SUNDRY NOTICES AND REPORTS ON WELLS
Do not use this form for proposals to drill or to re-enter an abandoned well. Use form 3160-3 (APD) for such proposals.

8. Well Name and No.
RATTLESNAKE 28 FED COM 704H

Rattlesnake 28 Fed Com 704H
30-025-42876
EOG Resources, Inc
Surface Location: Sec. 28, T. 26S, R. 33E
Conditions of Approval

10-3/4" X 7-5/8" X 5-1/2"
FBD-100 WELLHEAD SYSTEM
QUOTE # - 93482

DRAWING NO
WH-15848

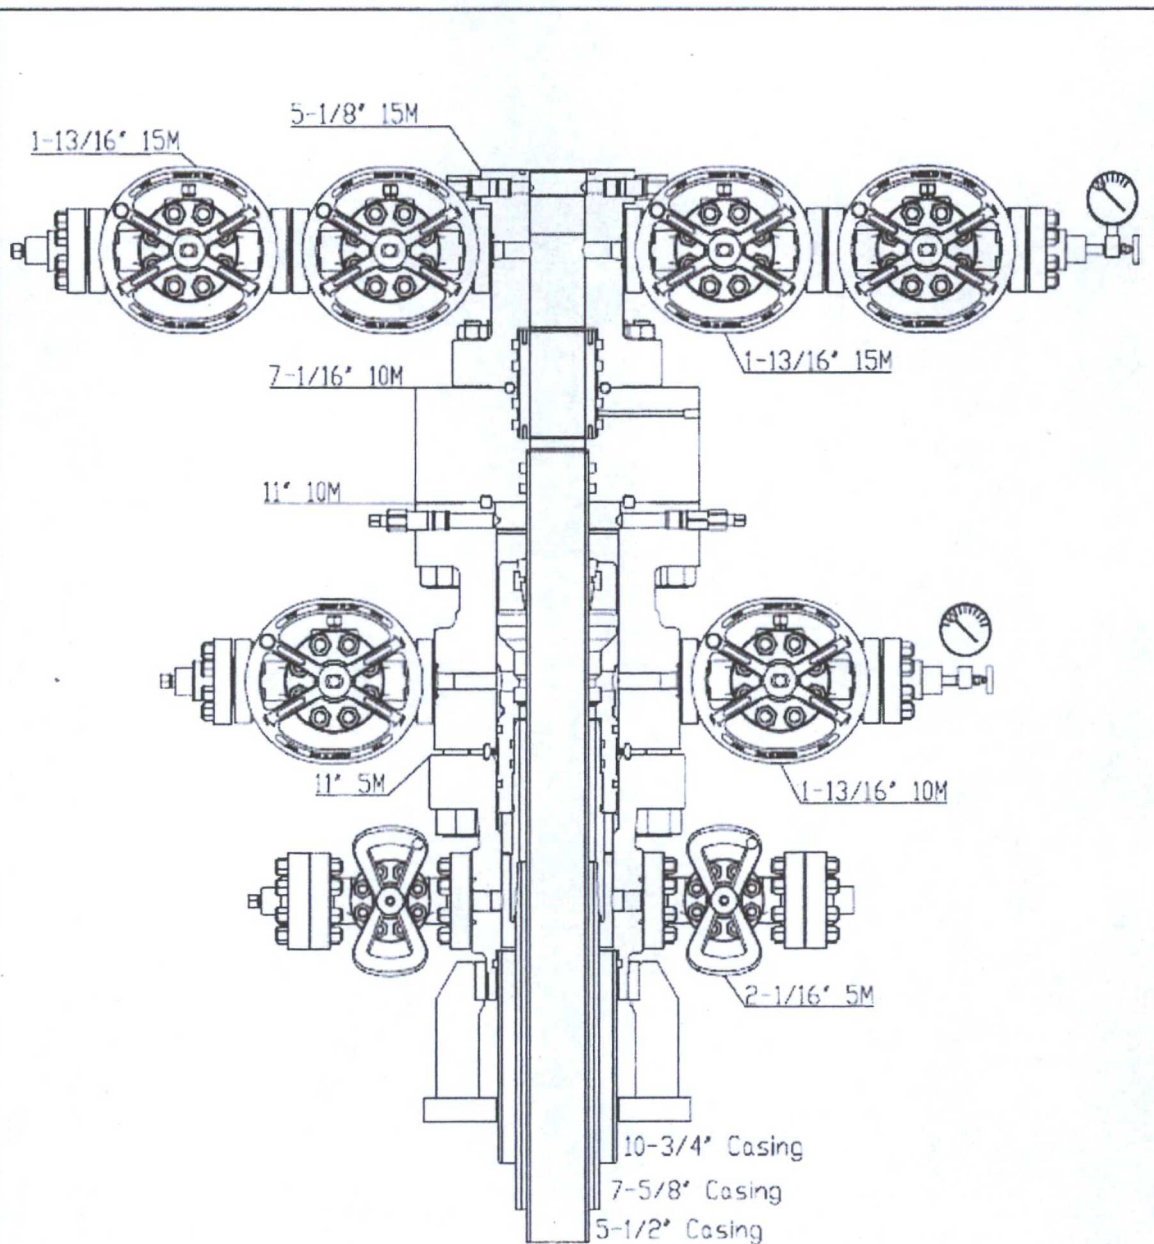
See below for the conditions of approval for the multi-bowl wellhead system.

1. All blowout preventer (BOP) and related equipment (BOPE) shall comply with well control requirements as described in Onshore Oil and Gas Order No. 2 and API 53.

2. Operator has proposed a **multi-bowl wellhead assembly**. This assembly (BOPE/BOPE) will be tested when installed on the surface casing. Minimum working pressure of the blowout preventer (BOP) and related equipment (BOPE) required for drilling below the surface casing shoe shall be **5000 (5M) psi**.

- a. Wellhead shall be installed by manufacturer's representatives, submit documentation with subsequent sundry.
 - b. All BOP equipment will be tested utilizing a conventional test plug. Not a cup or J-packer type.

- c. If the welding is performed by a third party, the manufacturer's representative shall monitor the temperature to verify that it does not exceed the maximum temperature of the seal.

- d. Manufacturer representative shall install the test plug for the initial and all BOP testing.
 - e. **Prior to running the intermediated casing, the rams will be changed out to accommodate the 7-5/8" casing. After installing the intermediate casing the casing rams will be removed and replaced with variable bore rams.**

3. Operator has broken a seal on the BOP stack therefore per Onshore Oil and Gas Order No. 2 **the entire BOP stack shall be tested prior to drilling out the intermediated casing.**

- a. A solid steel body pack-off will be utilized after running & cementing the intermediate casing. After installation of the pack-off and lower flange will be pressure tested to 5000 psi.

- b. If the cement does not circulate and one inch operations would have been possible with a standard wellhead, the well head shall be cut off, cementing operations performed and another wellhead installed.
